Virgo change request

Quadrants photodiodes for BMS and MC end mirror

Responsible:	Name:	Cleva
	Email	Cleva.at.obs-nice.fr
	Institution:	CNRS / OCA – Artemis

Procedure start date:	21/12/2006
Procedure end date:	dd/mm/yyyy
Document version	v0r01
Version date	21/12/2006

Figure 1

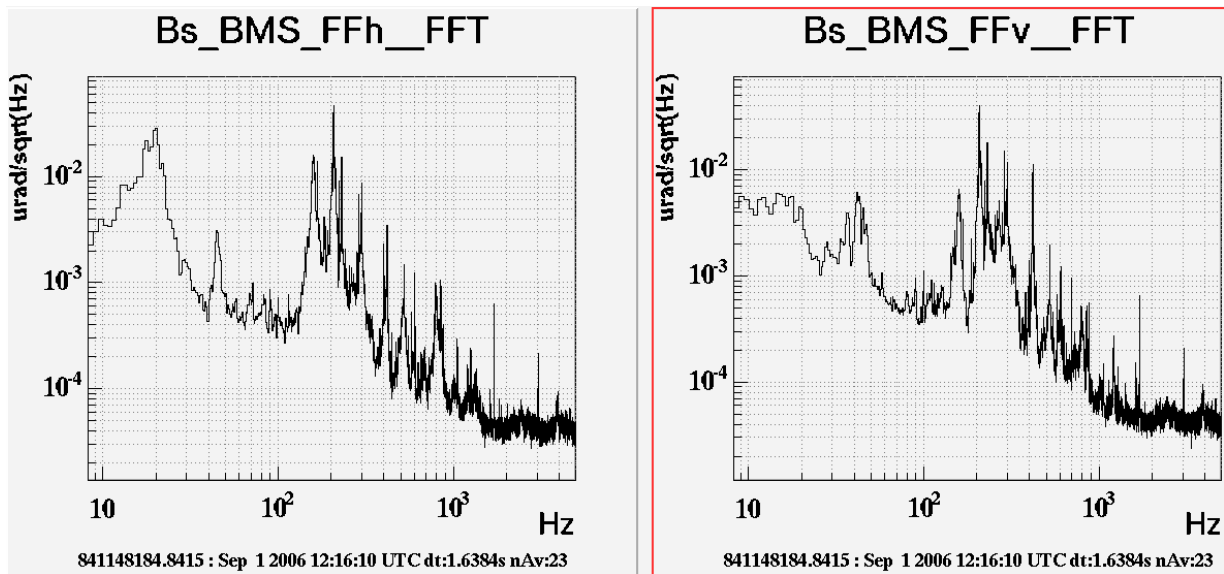
- Photodiodes are used in the "+" configuration (see Annex 4 – figure 1)
- One DC channel delivering the overall power (sum of 4 quadrants), assuming the incident power is about 6mW, and detector efficiency is 0.45A/W (silicium).

Figure 2

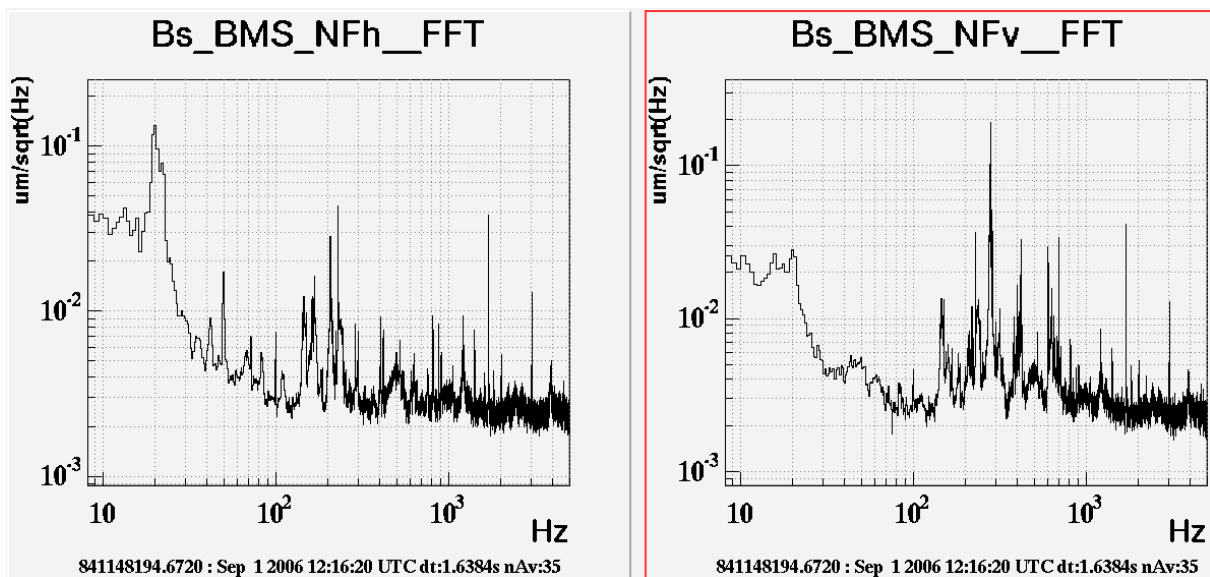
* Beam jitter level is supposed to reach $1\text{e-}5\text{ urad}/\sqrt{\text{Hz}}$ at 5kHz (extrapolation with $1/f$ slope from 1kHz , see Annex 4 - figure 2).

One needs to be able to detect beam jitter noise up to 5kHz .

Sensitivity for BMS_QF signal is $S = 2 \cdot \sqrt{2/\pi} / w \cdot a \cdot (i_{dc})$ with $a = 8 \cdot \theta$,
where, 8 is equivalent focal length of telescope, in meter

-> $S = 43 \text{ A/rad}$, [we need to detect 430pA/sqrt\(Hz\)](#) (that is $1e-5 \text{ urad/sqrt(Hz)}$)

Figure 3

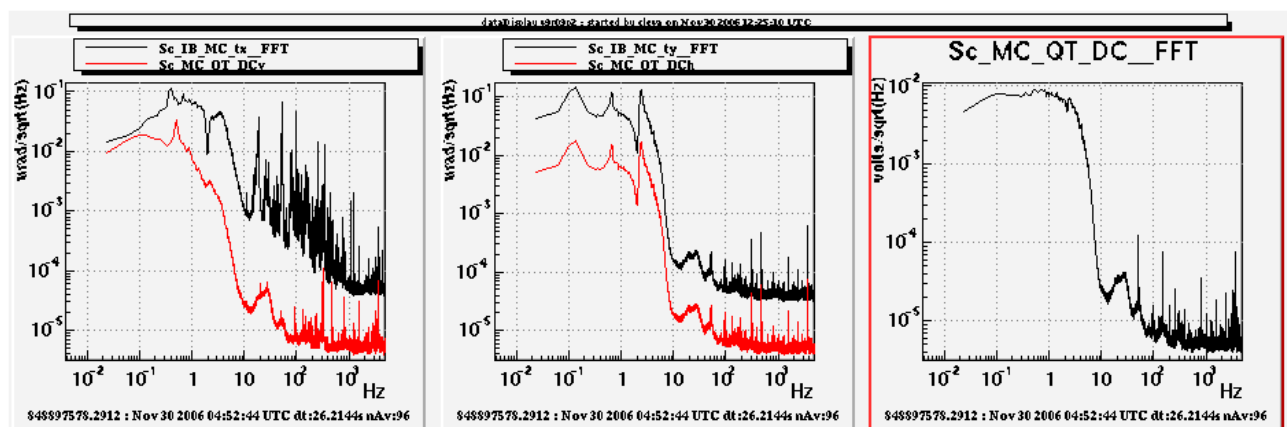
* Beam jitter level is supposed to reach $1e-4 \text{ um/sqrt(Hz)}$ at 5kHz (extrapolation with 1/f slope from 1kHz, see Annex 4 - figure 3).

One needs to be able to detect beam jitter noise up to 5kHz,

Sensitivity for BMS_QN signal is $S = 2 \cdot \sqrt{2/\pi} / w \cdot a \cdot i_{dc}$ with $a = 1,51 \cdot \delta$

-> $S = 2,17 \text{ A/m}$, [we need to detect 216pA/sqrt\(Hz\)](#) (that is $1e-4 \text{ um/sqrt(Hz)}$)

Figure 4

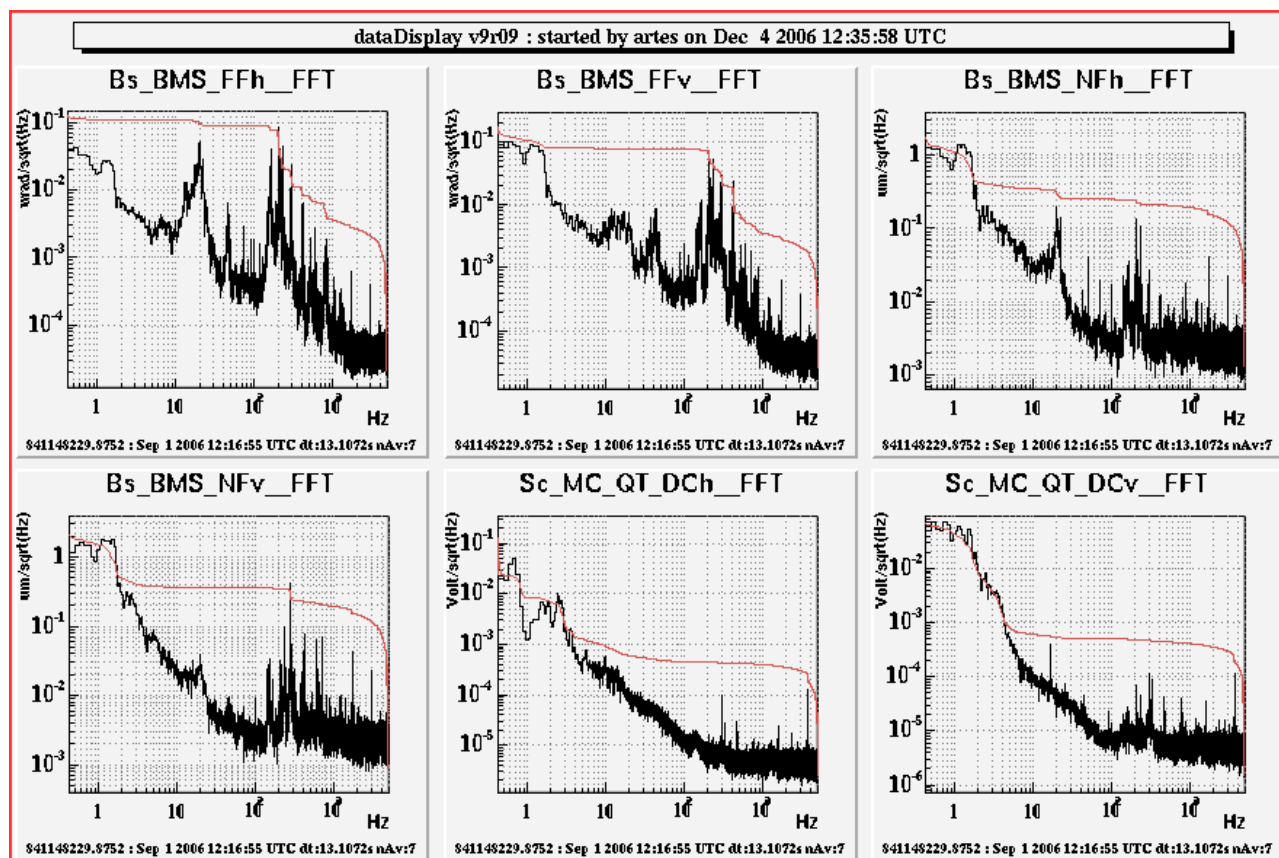
Figure 4 shows the error signal $Sc_{IB_MC_tx}$ (linear combination of $Sc_{MC_QT_DCv}$ and $Bs_{IMC_QF_ACv}$ signals).

$Sc_{IB_MC_tx}$ reaches a floor above 1kHz at 40 prad/sqrt(Hz) ; we fix the specification for that signal to be 4 prad/sqrt(Hz) .

[The specification of \$4 \text{ prad/sqrt\(Hz\)}\$ on \$\theta_x\$ is then reached for 278pA/sqrt\(Hz\) at the output of the photo-detector.](#)
